Planning & Development Report to
Calgary Planning Commission
2020 November 05

ISC: UNRESTRICTED
CPC2020-1212

Development Permit in Hillhurst (Ward 7) at multiple properties, DP2020-3902

riddell kurzczaba **LOADING SWEEP PATHS SOLA** 2020-08-31 **DP - REVISION 1 A-10**
 #19-4592 211-221 14th STREET PLAN 6219L BLOCK 3 LOTS 3 - 9 & PARTIAL 10 **SCALE: NTS**

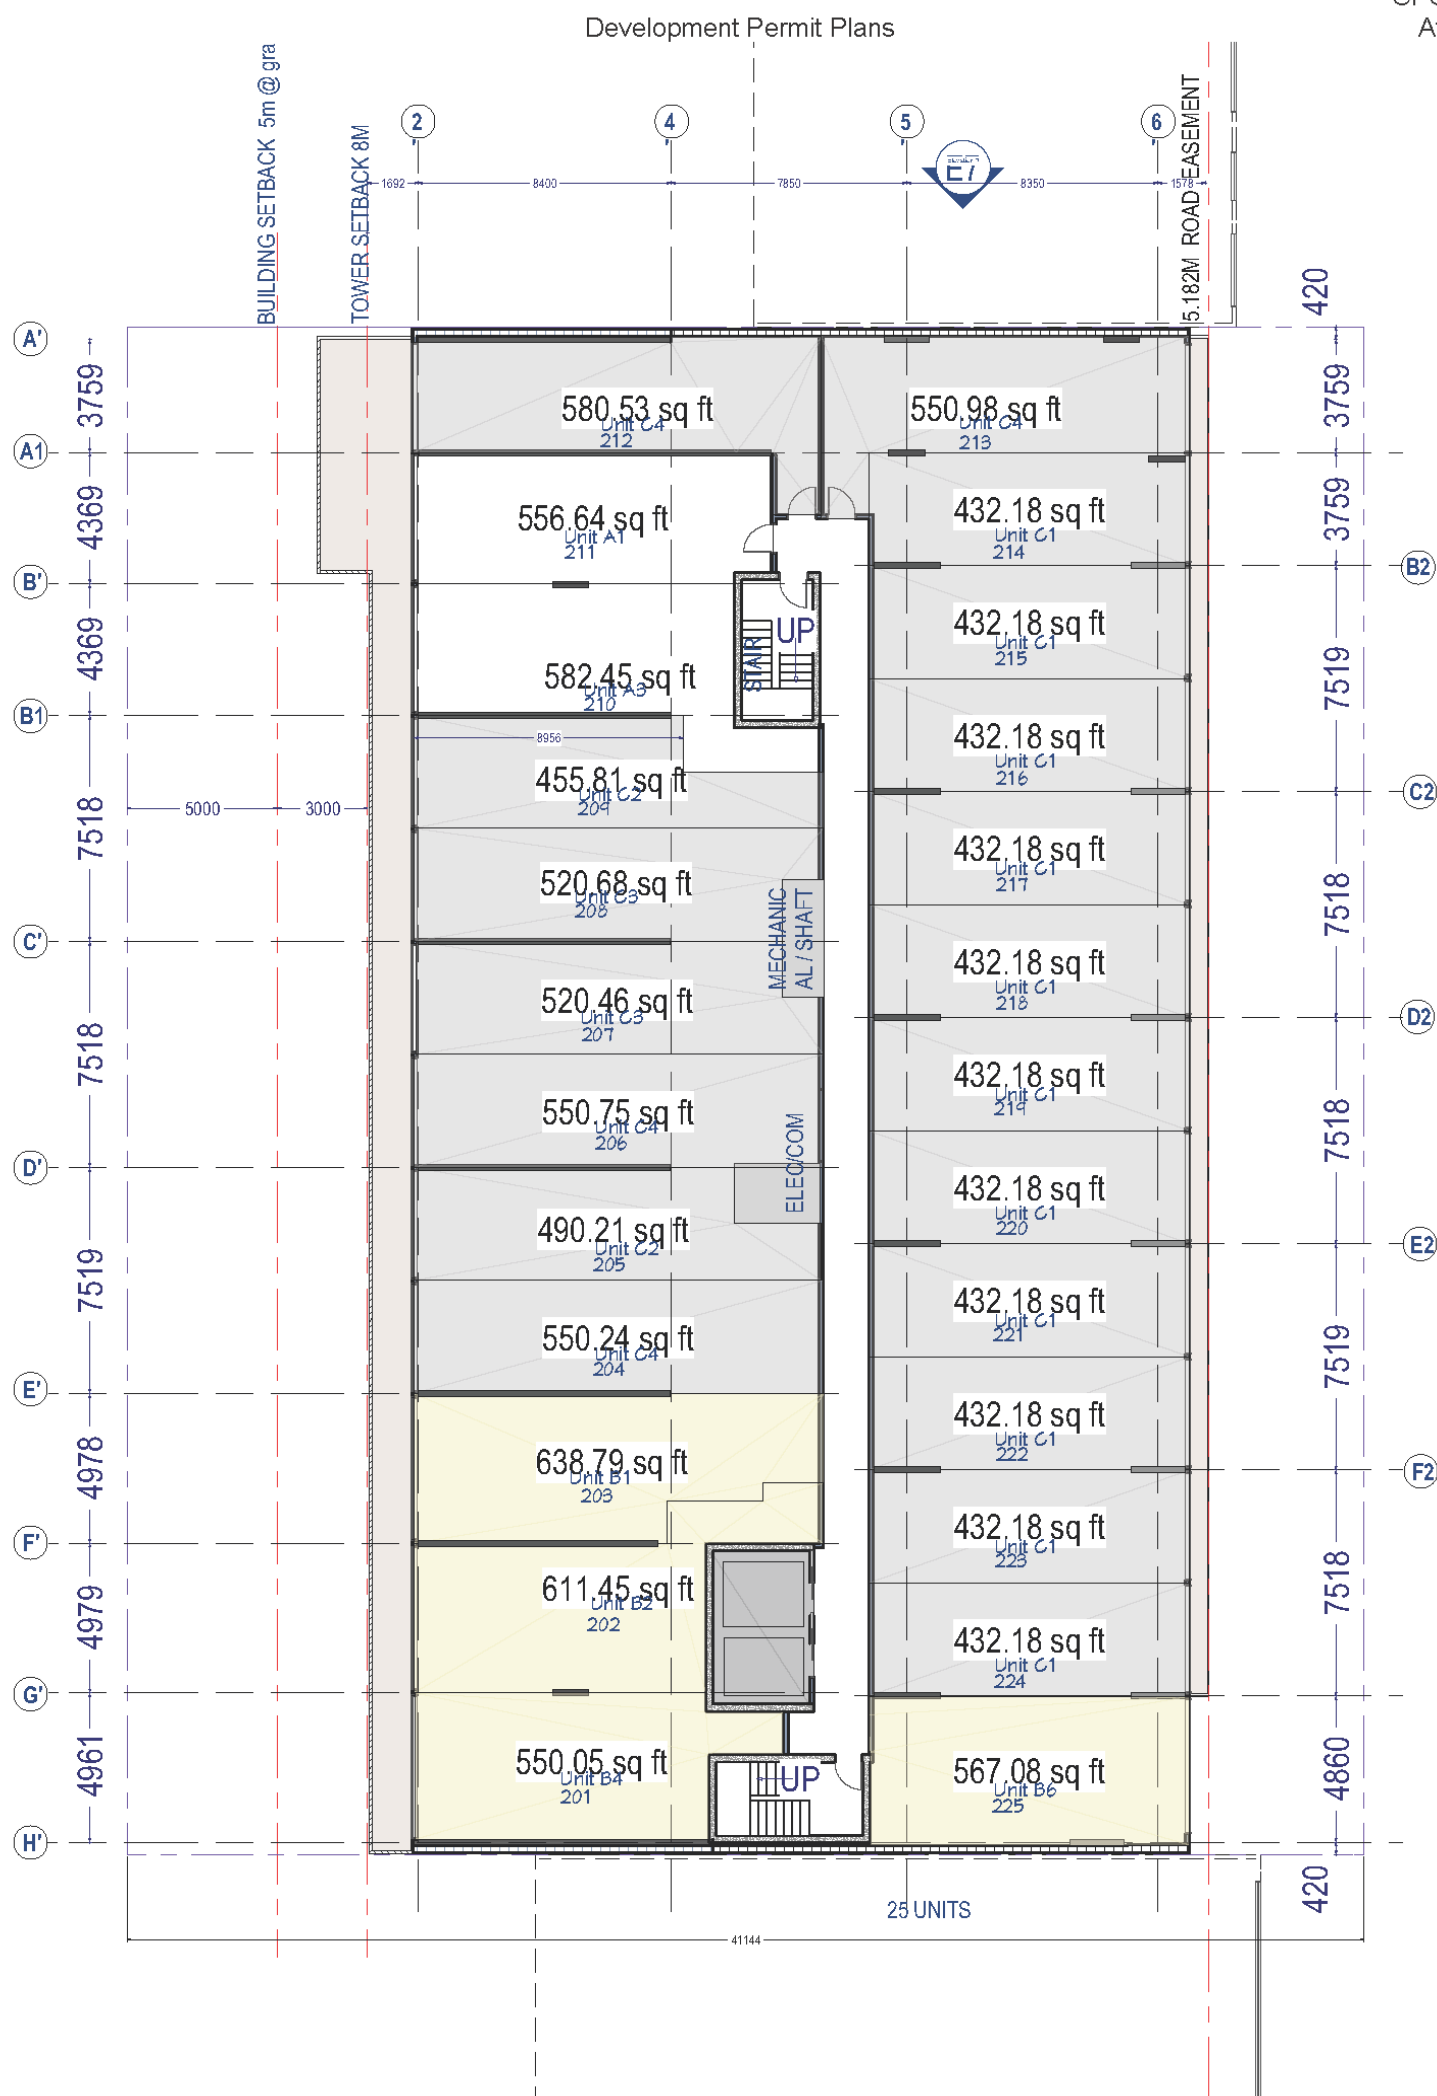
1. *"The overhead power lines make it necessary to load garbage completely from the lane."* Does that mean garbage/compost/recycling bins will all be pulled back from the building past the power line setback, or past the rear property line into the lane? Please identify on site plan the intended area where bins would be pulled out to waiting for pick up.

5. It appears the overhead powerlines imposes constraints on truck size and required bins to be pulled out for pick up. Has the Applicant/City Administration looked at putting this underground to remove the constraints? This could be a good potential site improvement item for bonus density.

This sweep path analysis reviews 3 truck sizes. From large to small SU9 9.1m, DL23 7.01m and LSU 6.4m. The loading sweep paths for the 6.4 Meter long truck (TAC 2017 LSU) is the smallest of the trucks but represents the practical maximum size that can be accommodated. As the units in the building are very small the recommended moving vehicle size as defined by U-haul is a 17ft truck, The 6.4 meter truck fulfills the loading requirements of the residential units and of the retail which will primarily be loaded with delivery vans.

The larger truck does not work under any scenario. Due to the location of the power poles and their distance apart there is no loading sweep path that functions. This version has the truck failing on one of the power poles. We are not assuming that 2 medium or large trucks would load at the same time. We view that one loading stall could have been sought for and accepted as such the 2 stalls provide good flexibility for multi-use such as a staging area for garbage as well as for loading.

On this site as in all the new developments in Kensington with narrow lanes there are challenges with loading. This proposal is consistent with the loading solutions recently approved in near by developments. The rule to load with the sweep path completely on site is not a reasonable requirement. The implications would eliminate much of the ground floor development foot print. We are asking for a relaxation consistent with others to allow the car parking stalls to back into the lane and to allow trucks using the two loading stalls to back into the lane as part of the normal course of access.

GARBAGE LOADING

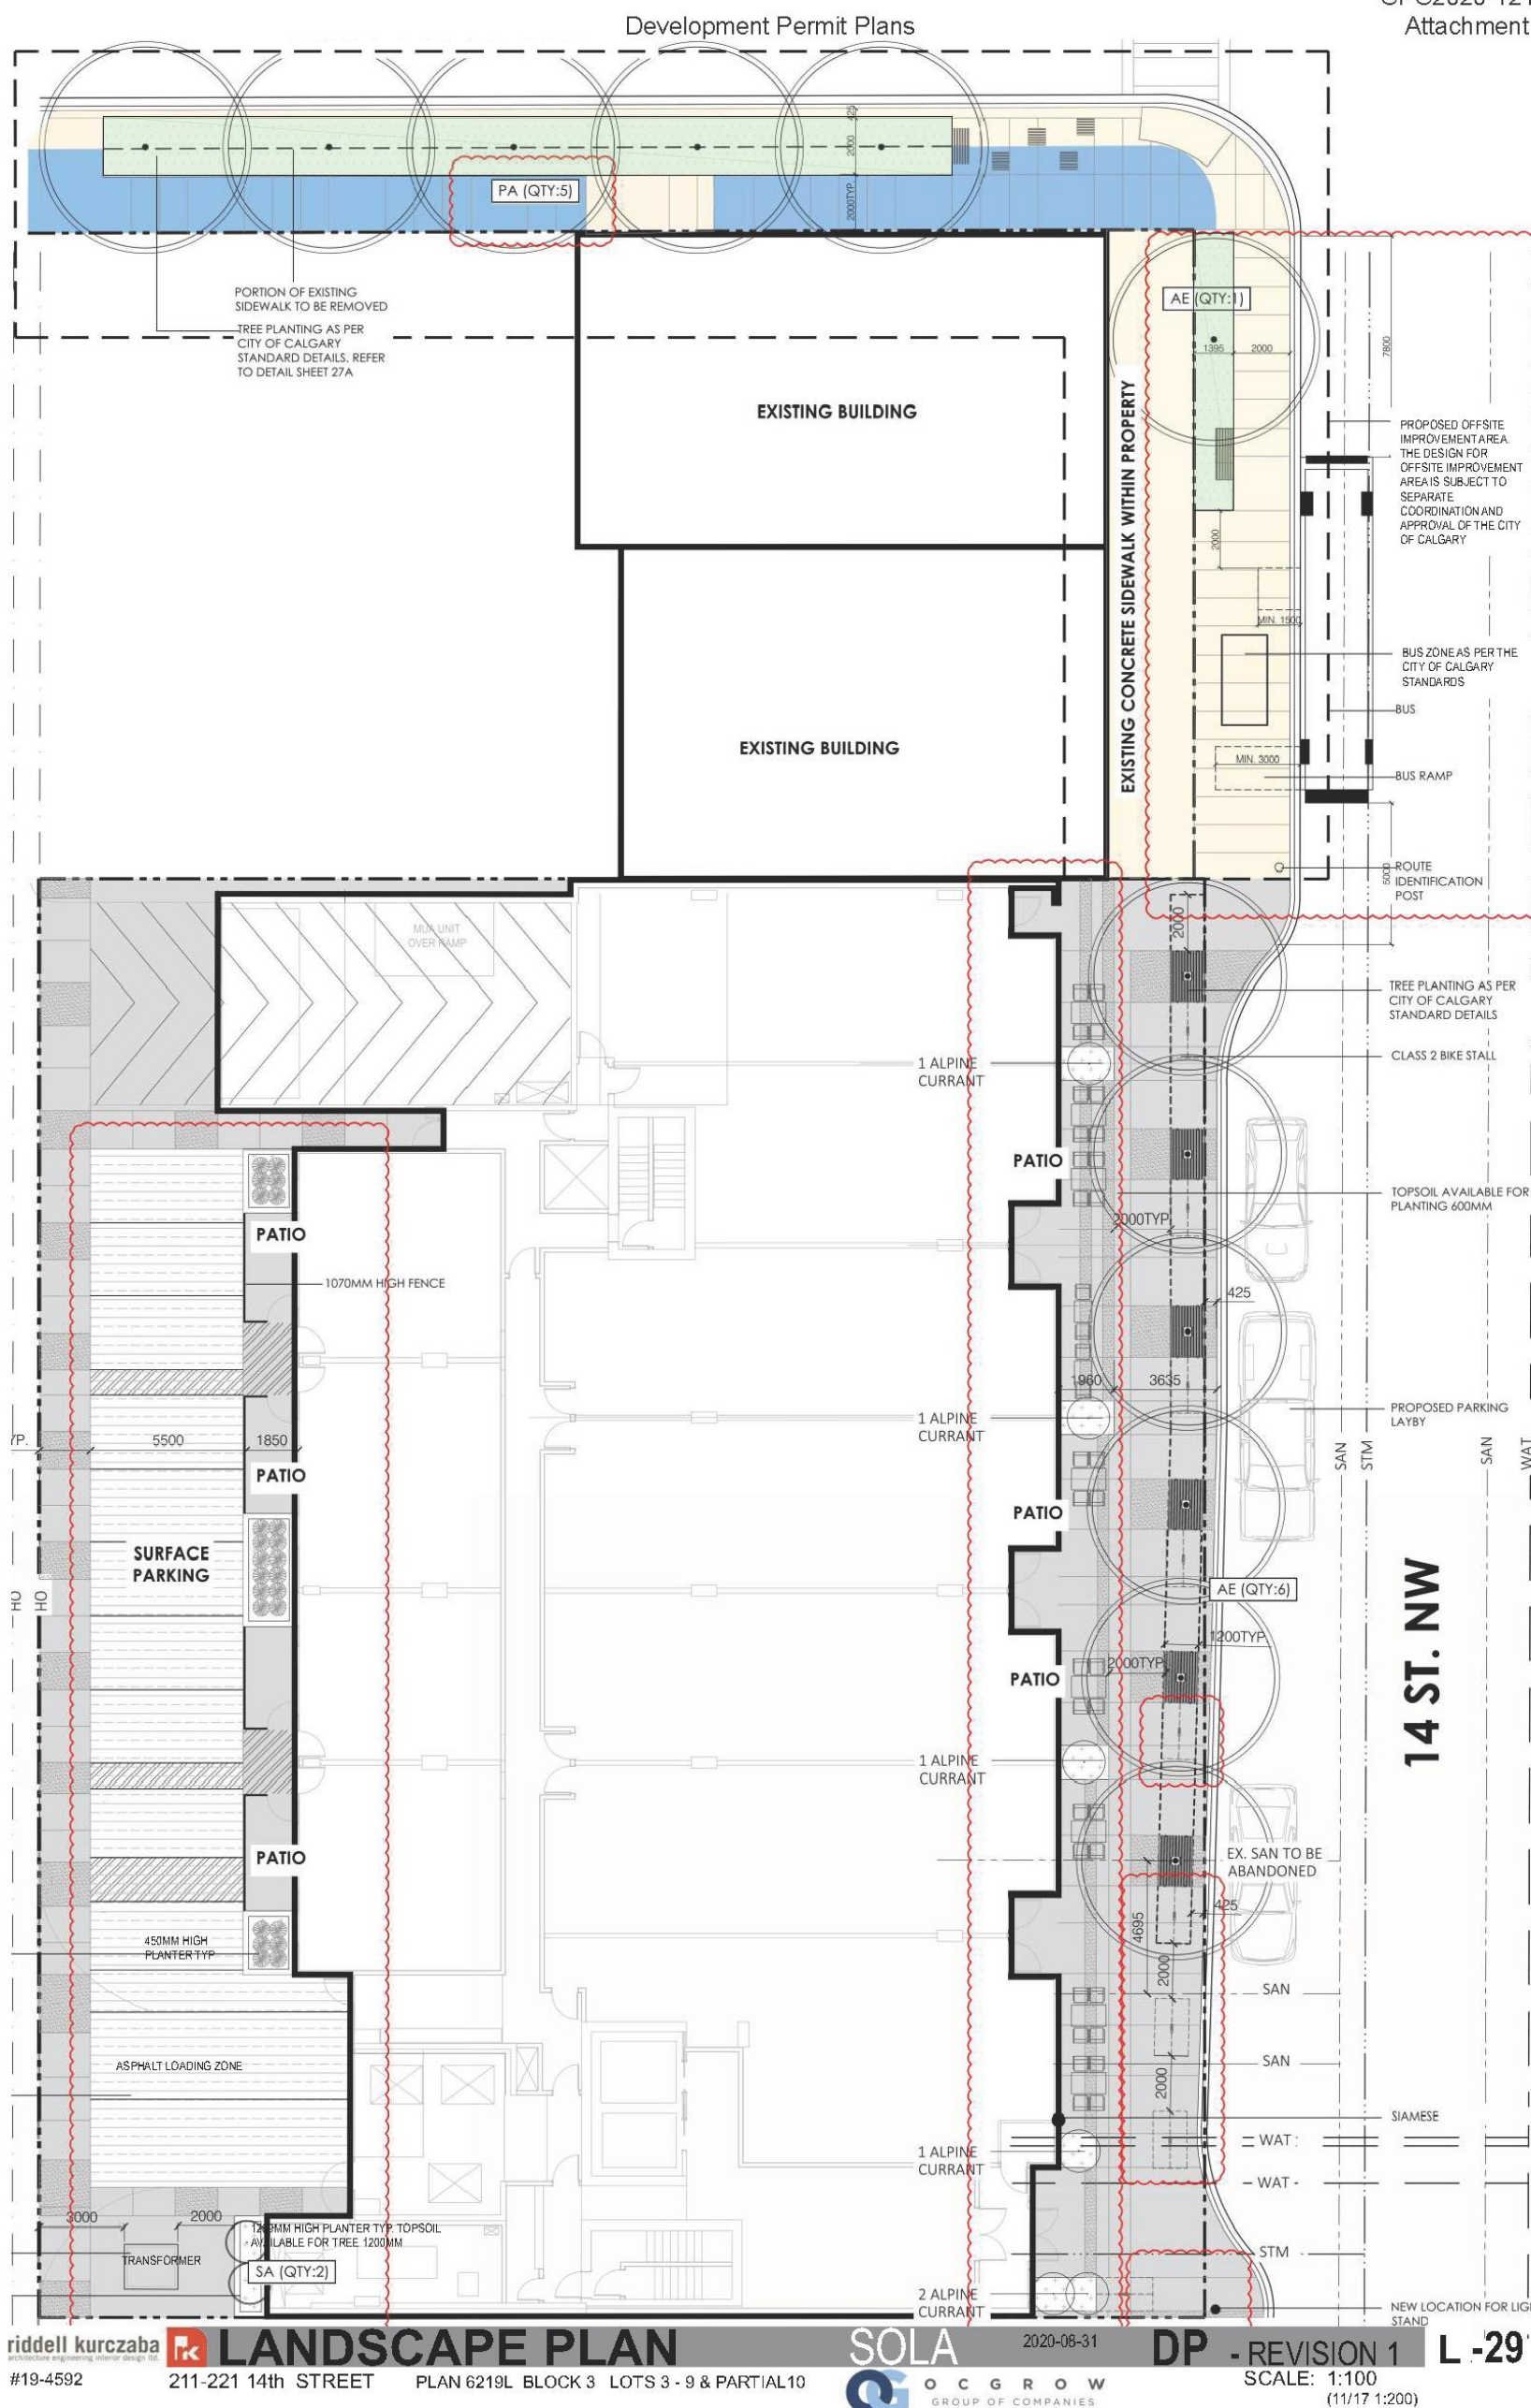
- a. Provide an overhead door (min. size of 3.0m wide X 2.1m high) and a separate man door with keypad access for the waste facility.

The overhead door is 12 ft wide by 9 ft tall to allow for direct removal of the bins with minimal sideways movement. A concrete curb is included to prevent bins from hitting the door track and interior walls and bollards have been added at the overhead door to protect the tracks. The interior walls are also of concrete to ensure the space can withstand the abuse of moving the bins.
